## ORIGINATION FORM

Proposed Revisions to a Standard Plans Index  
(Please provide all information — Incomplete forms will be returned)

Index Number: 455-001

Index Title: Square Prestressed Concrete Piles - Typical  
Details & Notes

INDEX	SHEET
455-001	1 of 1

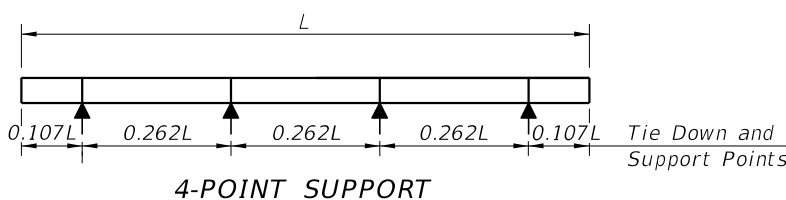
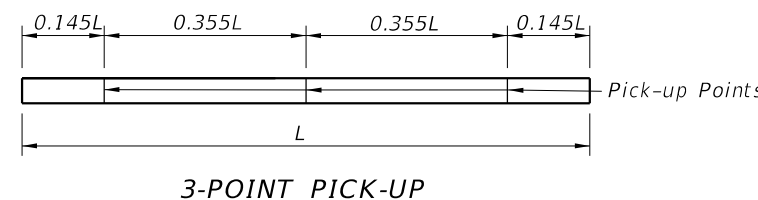
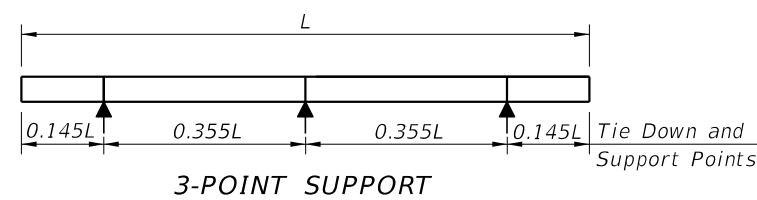
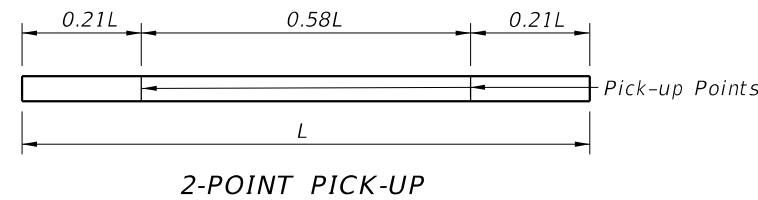
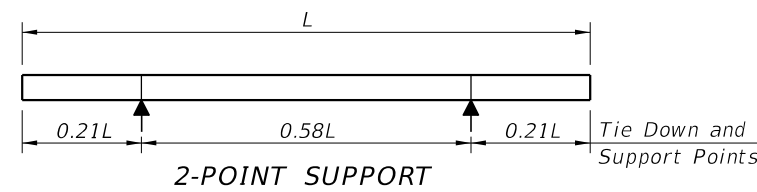
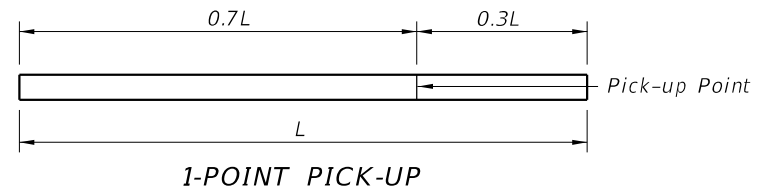
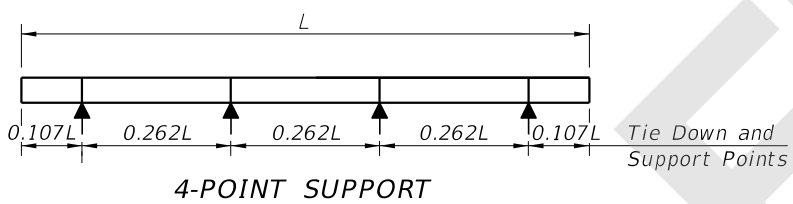
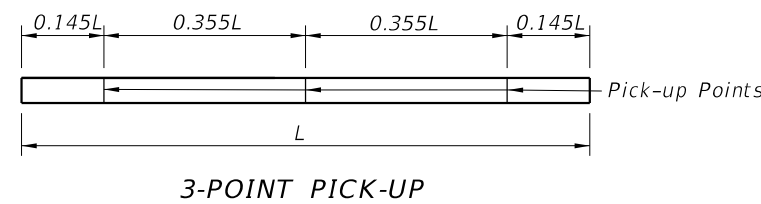
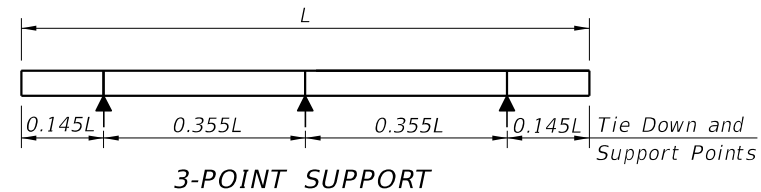
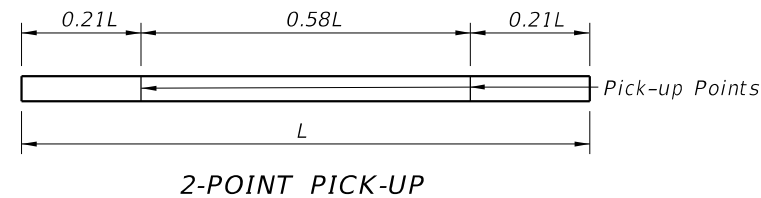
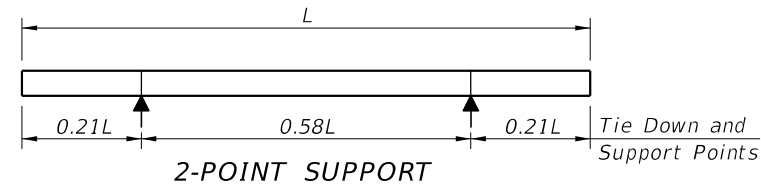
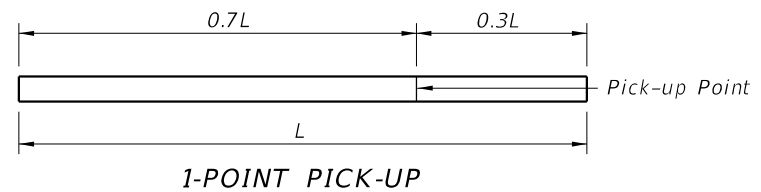
Change Silica Fume, metakaolin or ultra-fine flyash to Highly Reactive Pozzolans

Specification changed to fit silica fume, metakaolin and ultra-fine flyash under Highly Reactive Pozzolans

- C. ~~Silica Fume~~: See "GENERAL NOTES" in the Structures Plans for locations where the use of ~~silica fume, metakaolin or ultra fine flyash~~ is required.

Highly Reactive Pozzolans

- C. See "GENERAL NOTES" in the Structures Plans for locations where the use of Highly Reactive Pozzolans is required.
3. Concrete strength at time of prestress transfer:
